ALTAMONT ZONING BOARD OF APPEALS

# LANDS OF CM FOX LIVING SOLUTIONS LLC MAJOR SUBDIVISION

November 20, 2023

Re: CM 11 Lot Subdivision Project-comment letter

110

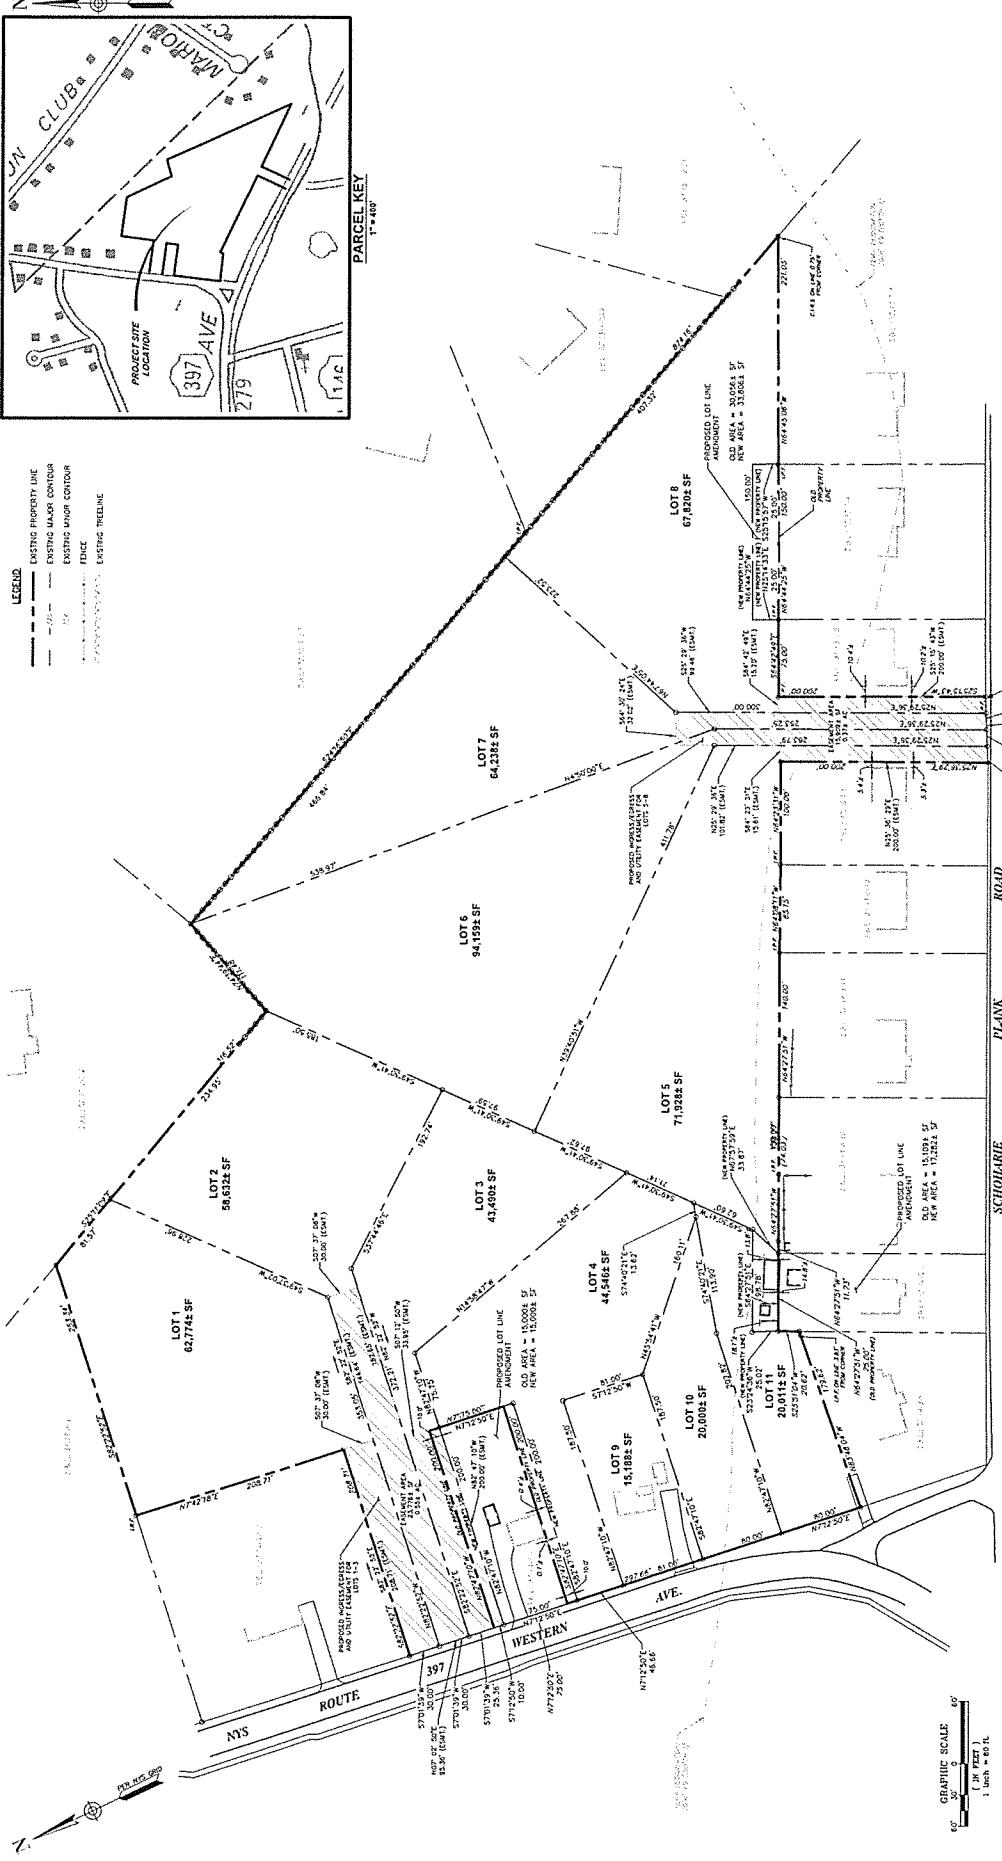
*Sheet C-110-Subdivision Plat*

1. Note 11 mentions driveway construction for 50,000 lbs. fire truck. Plans need to indicate which driveways this applies to regardless of length.

C-130

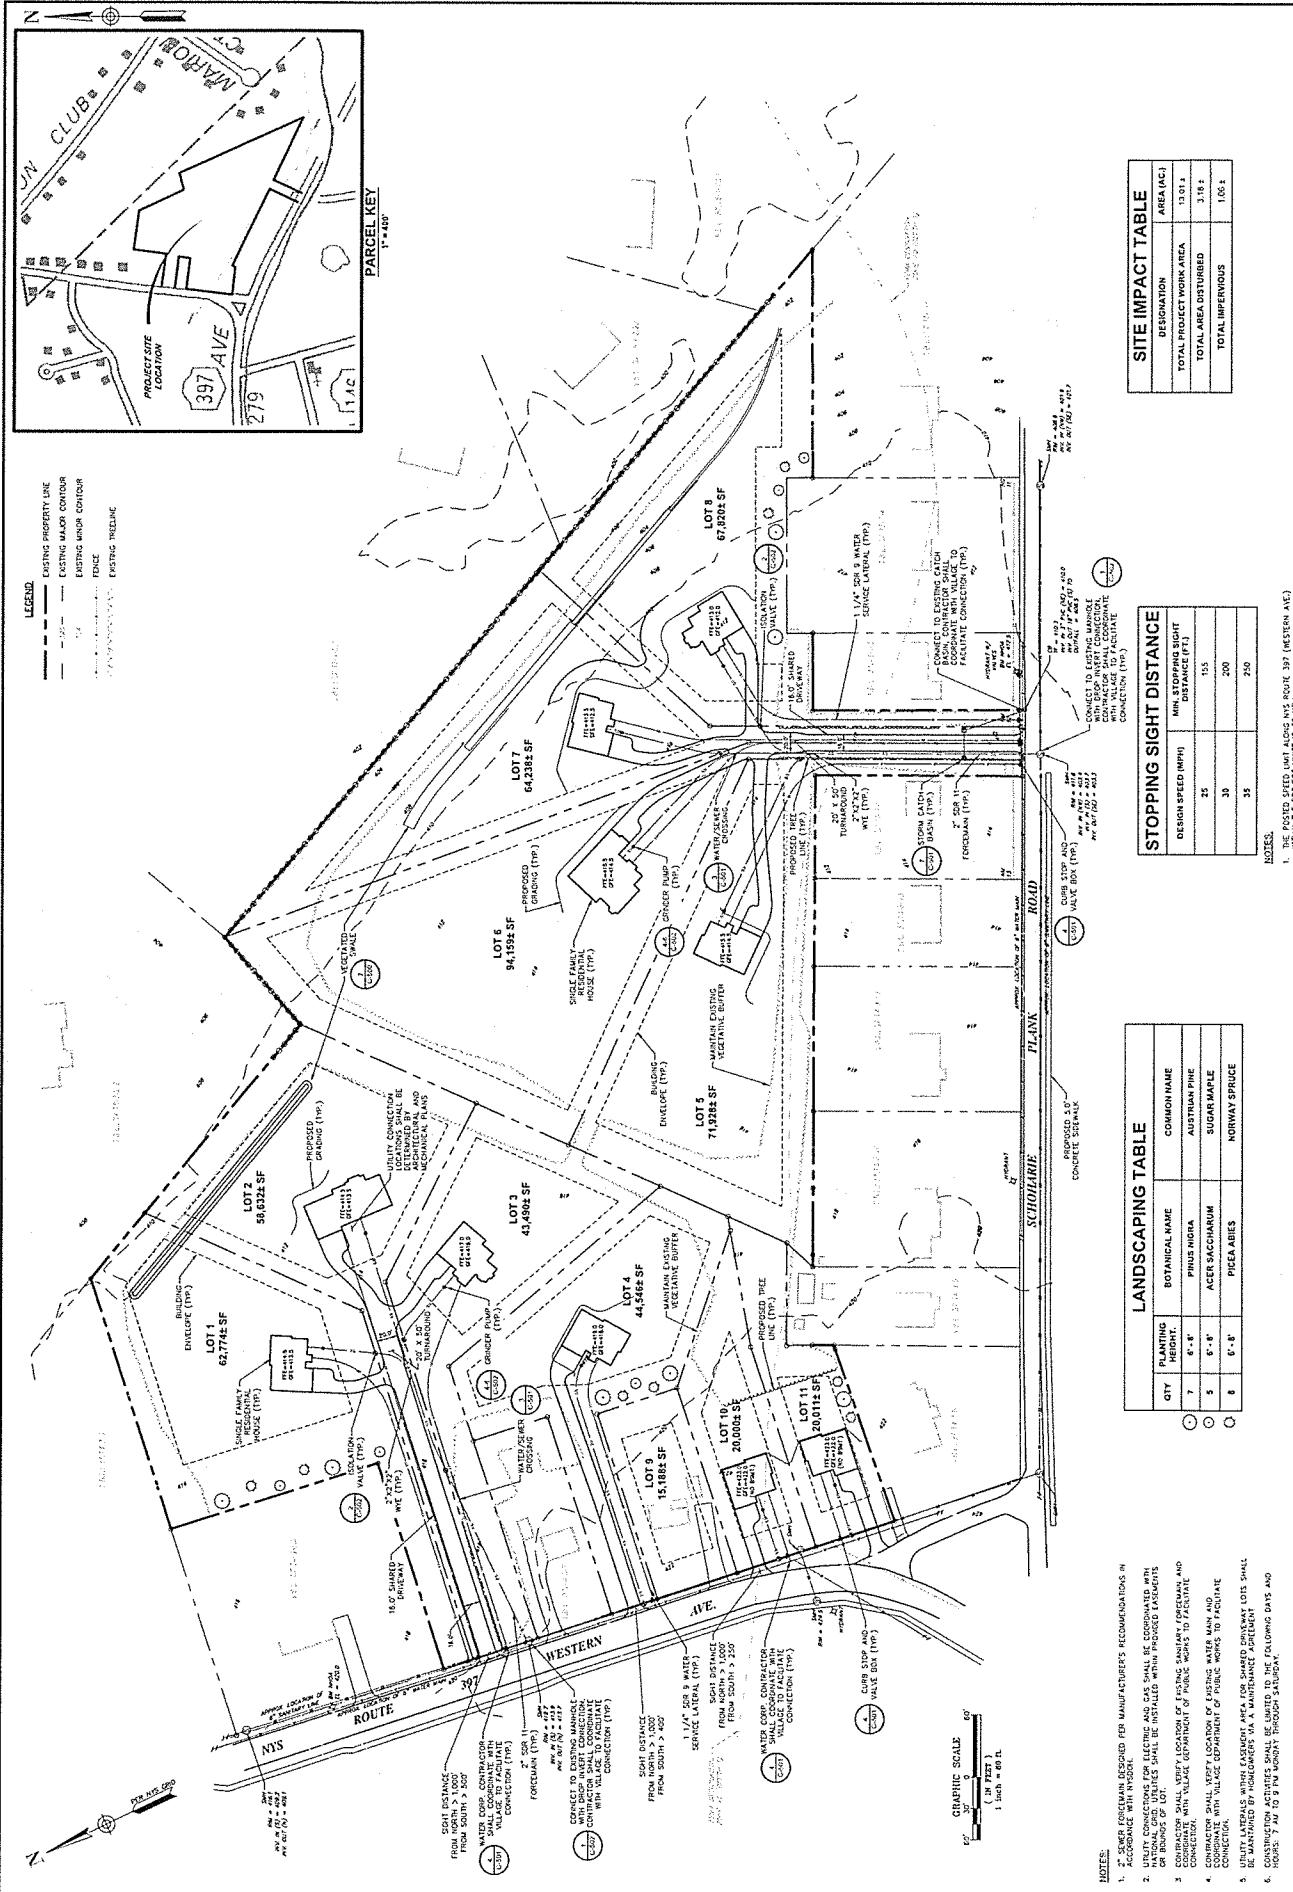
*Sheet C-130-Landscaping, layout & Utilities Plan:*

1. Label all proposed contours.
2. Indicate proposed drainage swale end elevations at north and south ends adjacent to Marion Court property lines. Northerly channel needs a weir elevation to discharge.

3. Where are the rain gardens previously discussed to receive roof drainage on each of the lots? Their storage value was intended to offset increases of impervious area from development in this sensitive area. The smallest lots could have smaller rain gardens.

4. Drainage of the property generally runs from west to east (Western towards Marion). There are no provisions for driveway culverts or consistent swales shown on the grading plans that allow runoff conveyance or avoidance or run-on drainage from one property to another except at lots 7 and 8.

5. During site walk-through provision of underground stormwater chambers were discussed near the end of swale on lot 1 to infiltrate some runoff. Please provide (4 sections) of 12" high PE chambers below ditch invert connected by grated vertical pipe 3" above bottom of swale.

6. Add notes to retain existing trees to provide screening and minimize area of disturbance. This applies to all lots.
7. Widen out discharge end of eastern swale through lots 7 and 8. Contour 402 should be 20' wide at end on lot 8. We recommend mixing some wildflower seed mix with grass seed for this 20'x10' end area for providing an erosion resistant vegetated area at discharge.

8. Provide screening shrubs/moderate sized trees/vegetation along driveways and houses on lots 1, 3, 4, 10, and 11 on the Western Ave. side. Provide screening with smaller species of conifers along driveways for lots 5, 6, 7 and 8 accessing WSP. Provide side yard trees for lots 5 to buffer new house location and add more than shown for lot 8. Screening for existing properties is important.

9. Add a 45 degree bend at sewer manhole connection that directs discharge to outlet pipe as opposed to perpendicular to flow to reduce splatter and odors.

10. Where are provisions of drainage for low area west of WSP driveways and connection to existing catch basin discussed during walk-through?
